7#调整前后对比

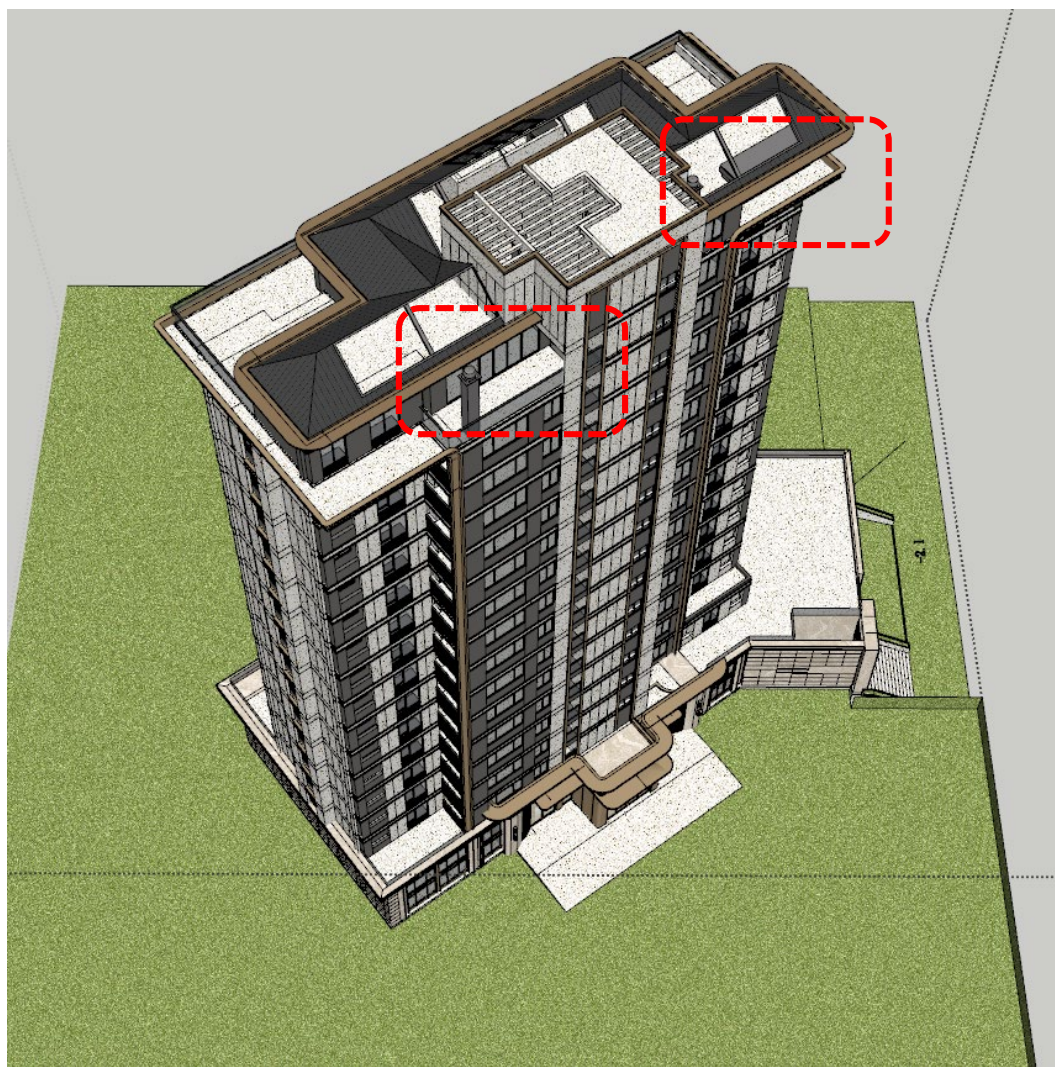
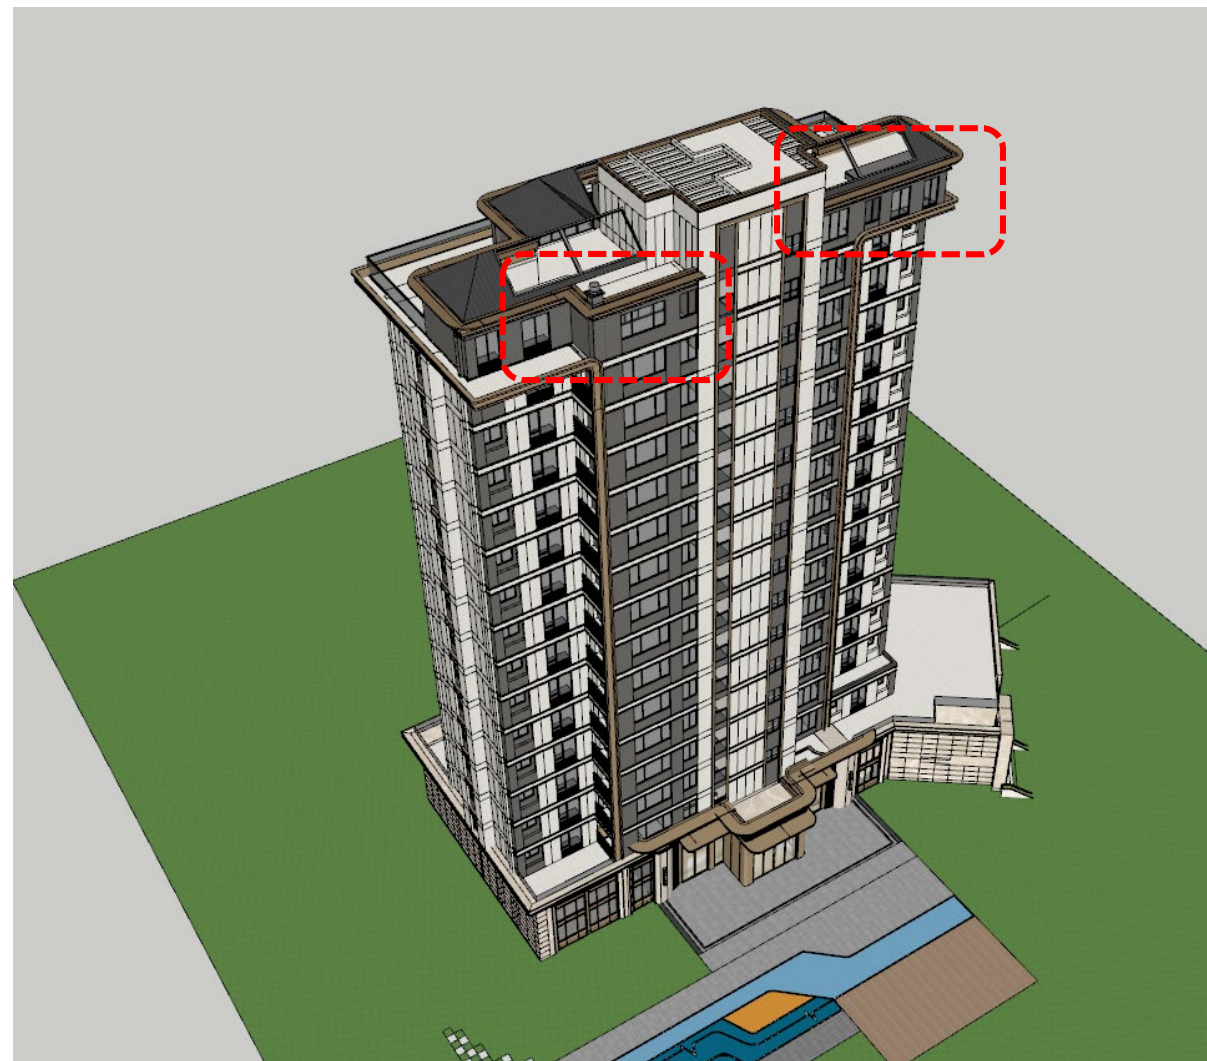
顶部造型调整

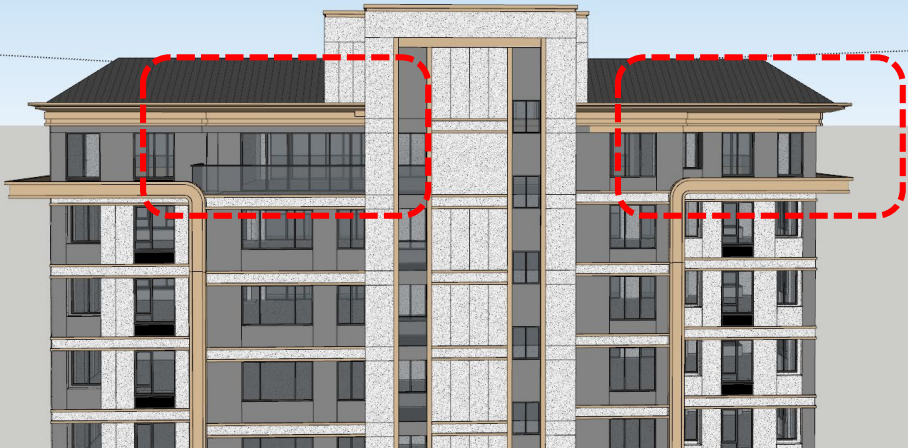
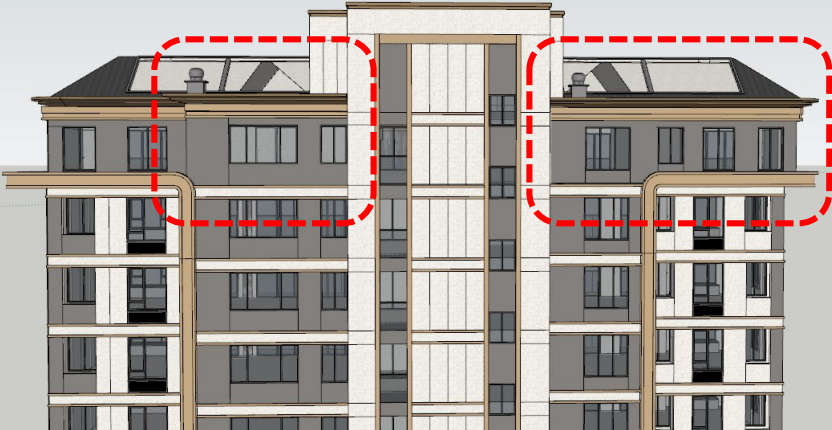
调整前

调整后

调整前

调整后

调整后7#十六层平面图

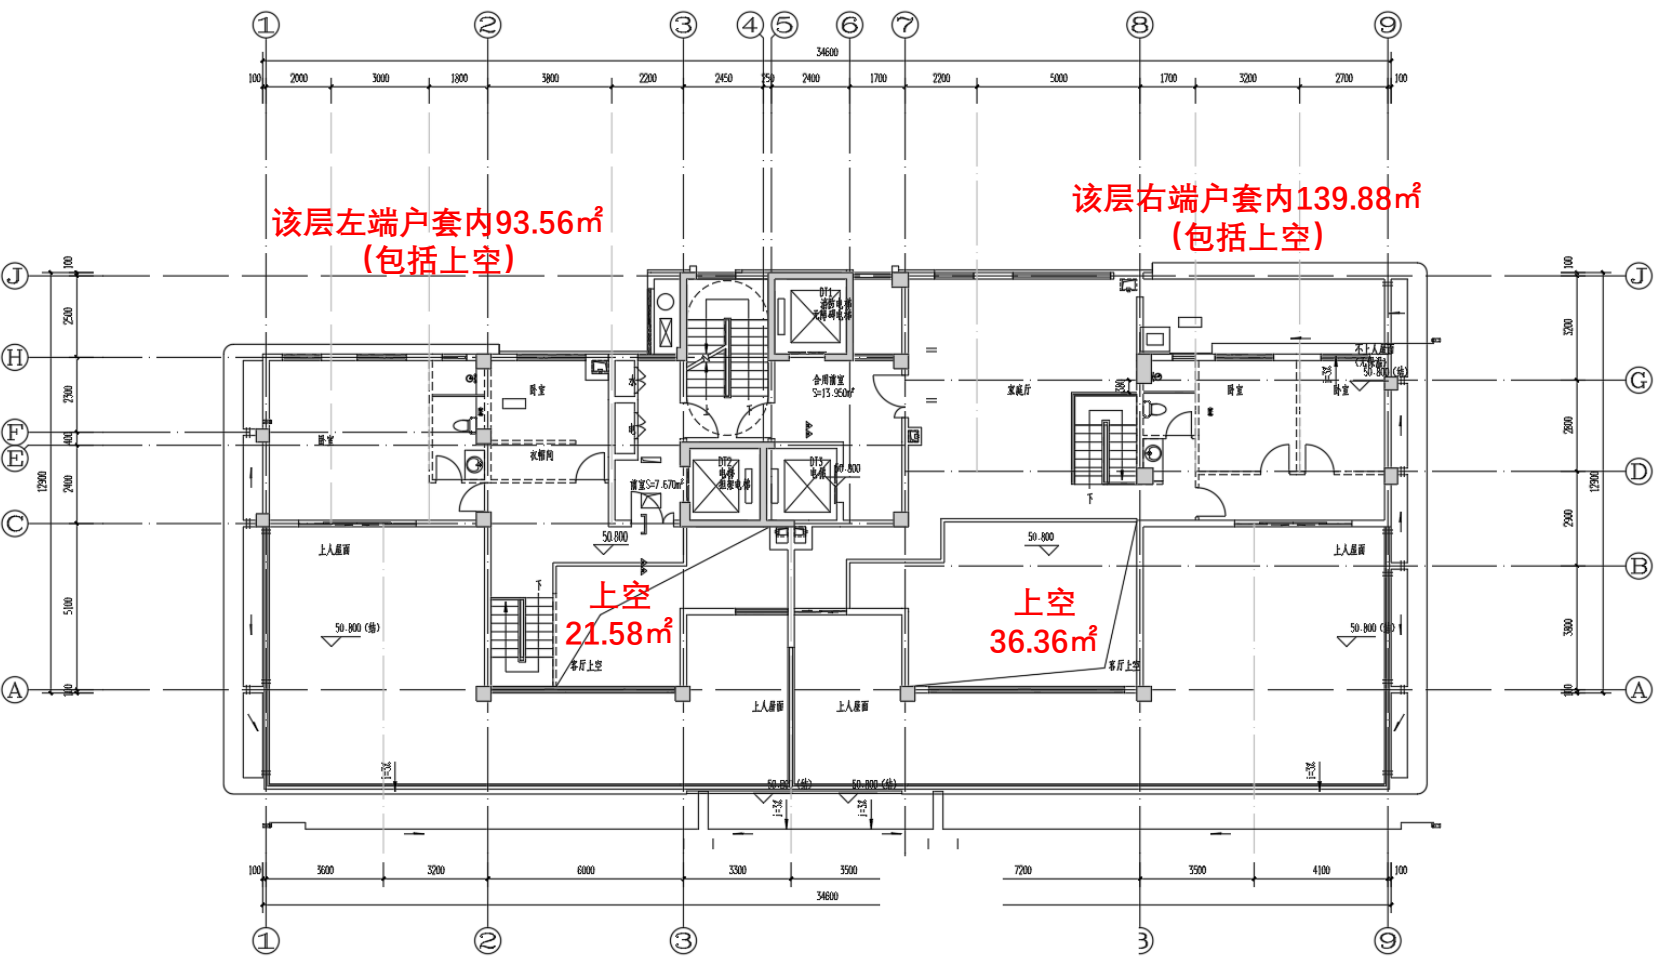
上空面积小于该户该层套内面积的30%比例，满足规范要求。

$93.56\text{m}^2 \times 0.3 = 28.06\text{m}^2 \geq 21.58\text{m}^2$

$139.88\text{m}^2 \times 0.3 = 41.96\text{m}^2 \geq 36.36\text{m}^2$
